Road Management Plan Review 2021

Prepared by Daniel Kade
Senior Operations Engineer
Roads and Maintenance
August 2021

Comment 7

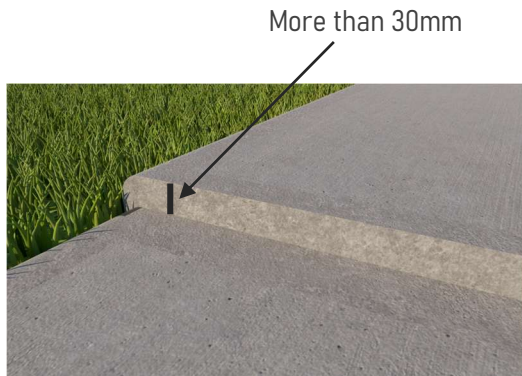
Consider changing the footpath intervention level from 30mm to 20mm for height differentials to reduce tripping hazards.

Operations Engineering will work with Asset Rehabilitation and management to determine if this proposal is achievable and appropriate to include in the RMP. The cost estimate to the budget for such a change is an additional \$1 million per annum. This will be recommended to Council for its consideration and approval. Removing all footpath height differentials was also considered, the estimated cost of doing this is \$4.7 million each year. This was considered a too higher cost and will not be recommended for consideration.
